# RECOMMENDED SERVICE BULLETIN

## RSB 42-089/1

## RSB 42NG-017/1

Replacement of seals in main landing gear damper.  
ATA-Code: 32-10

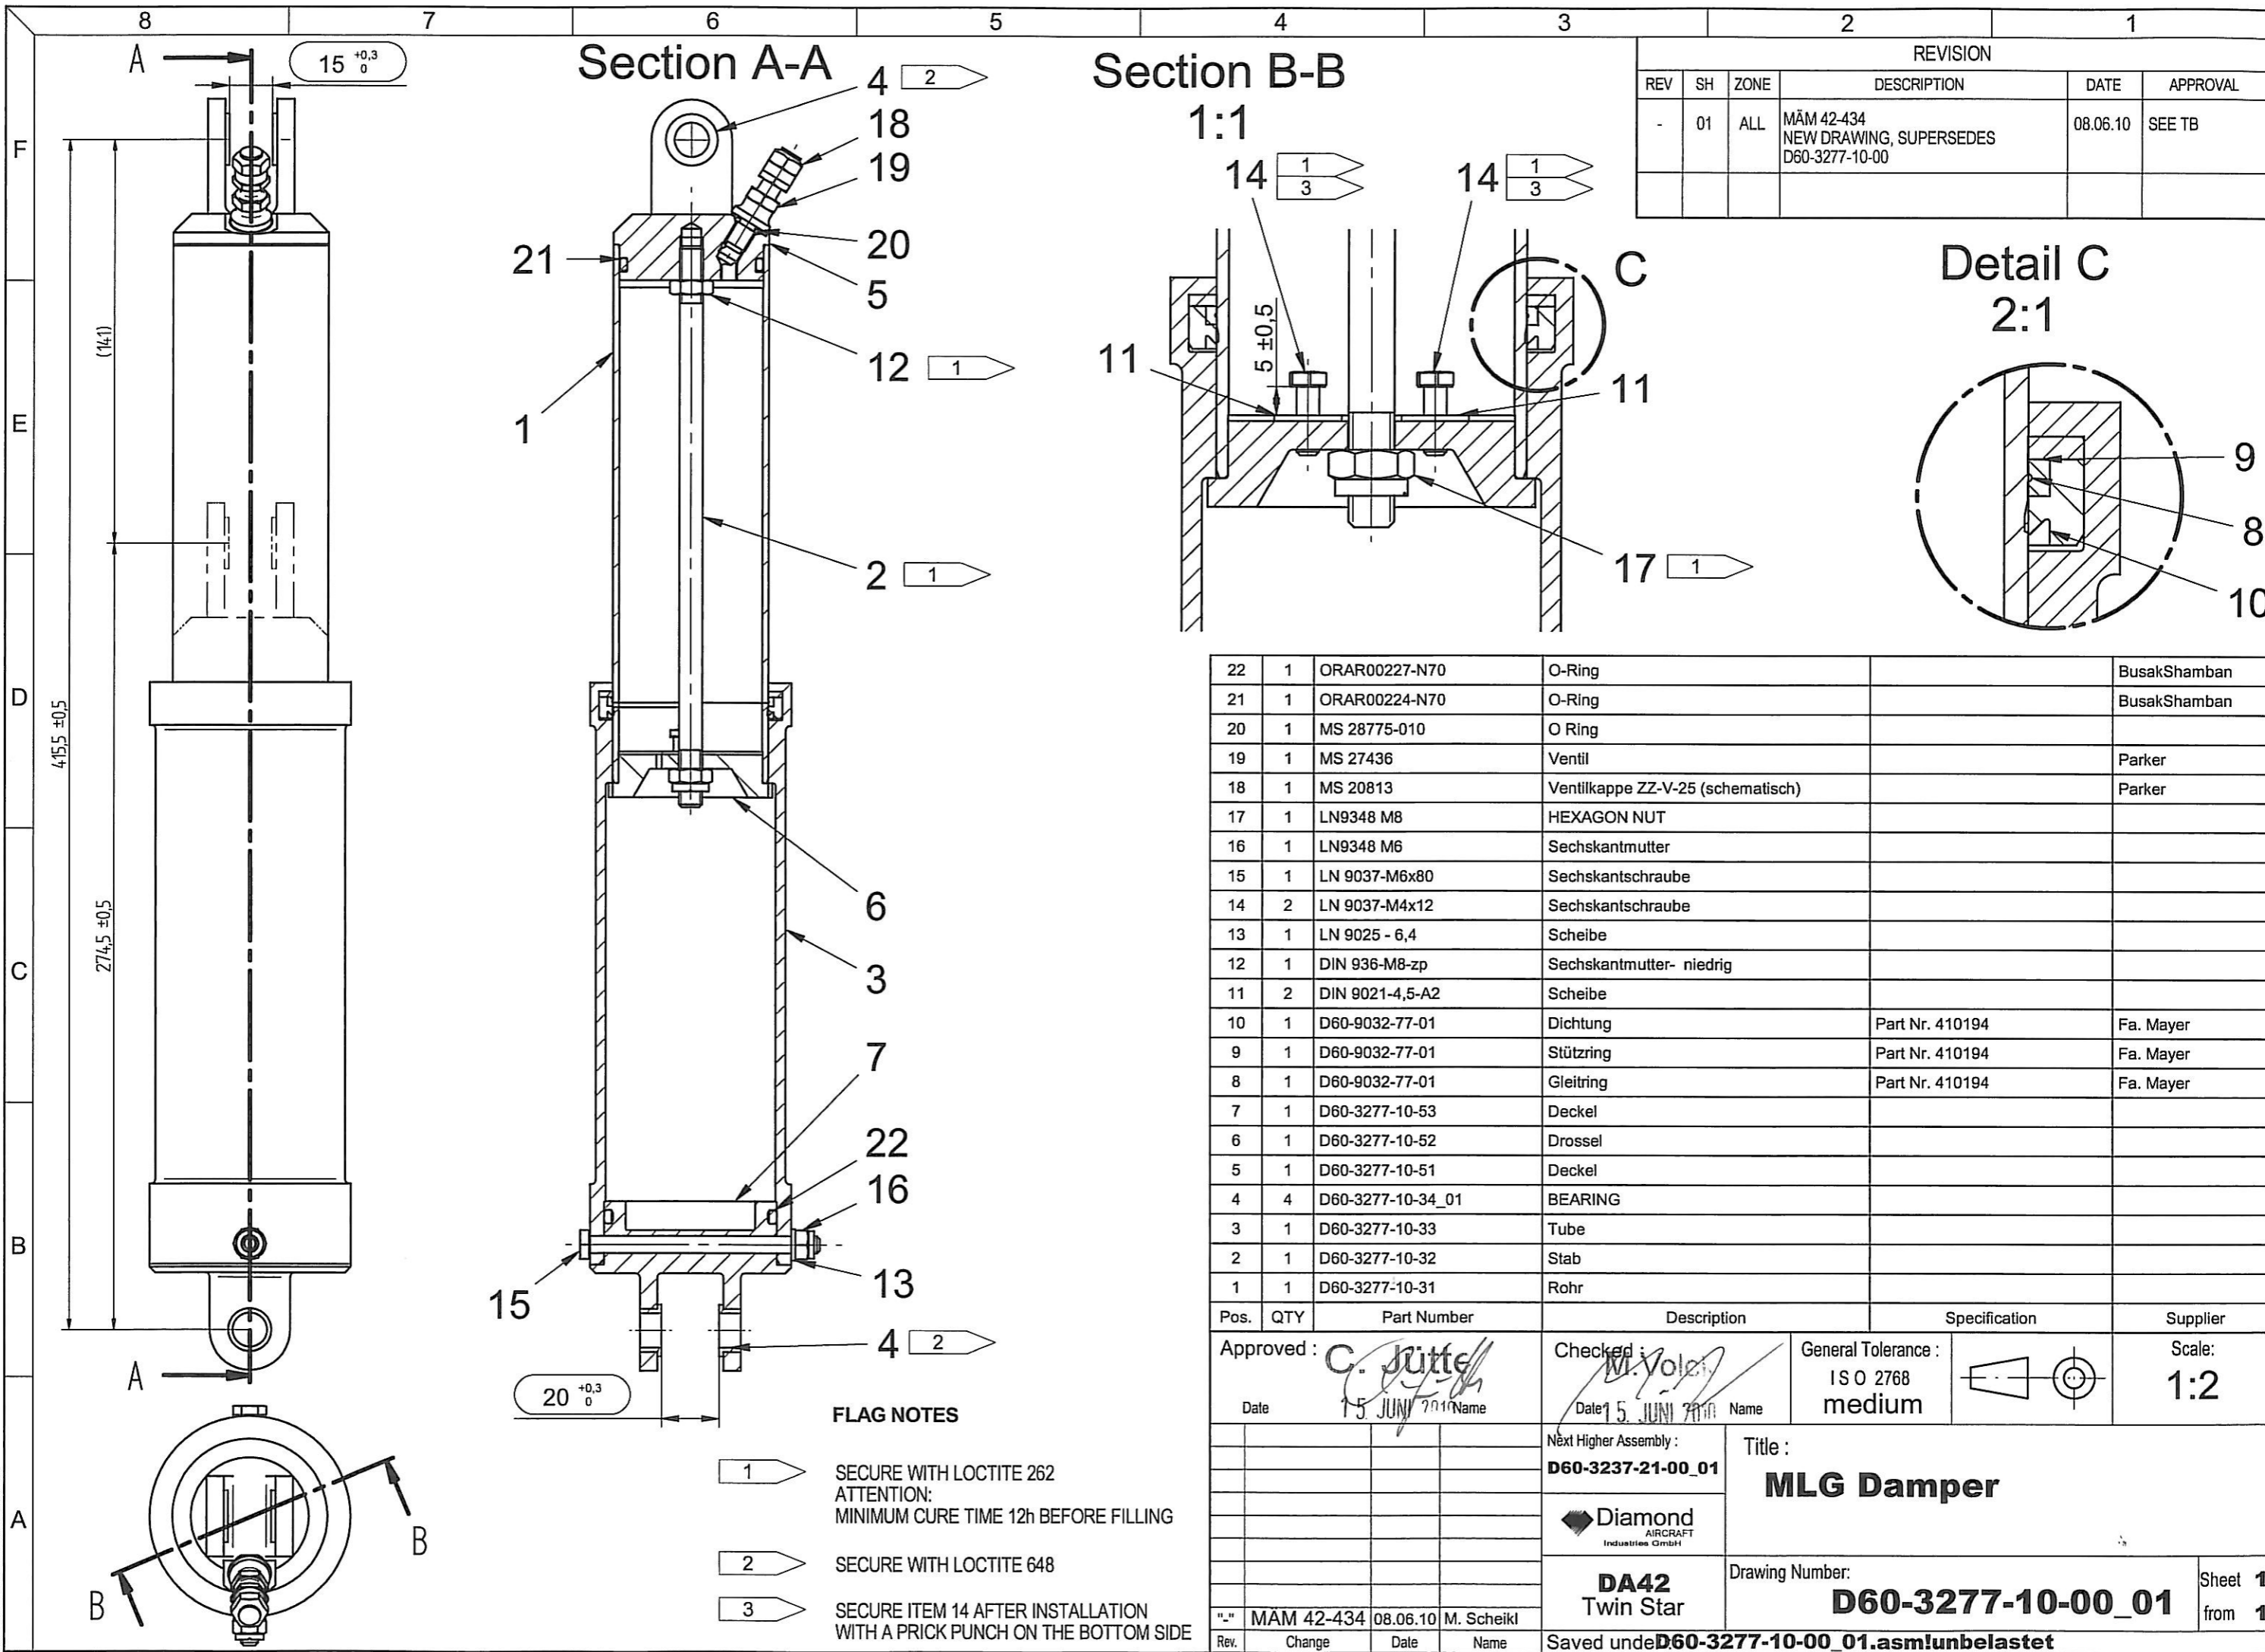
REVISION					
REV	SH	ZONE	DESCRIPTION	DATE	APPROVAL
-	01	ALL	MÄM 42-434 NEW DRAWING, SUPERSEDES D60-3277-10-00	08.06.10	SEE TB

- FLAG NOTES**
- 1 → SECURE WITH LOCTITE 262  
ATTENTION:  
MINIMUM CURE TIME 12h BEFORE FILLING
  - 2 → SECURE WITH LOCTITE 648
  - 3 → SECURE ITEM 14 AFTER INSTALLATION  
WITH A PRICK PUNCH ON THE BOTTOM SIDE
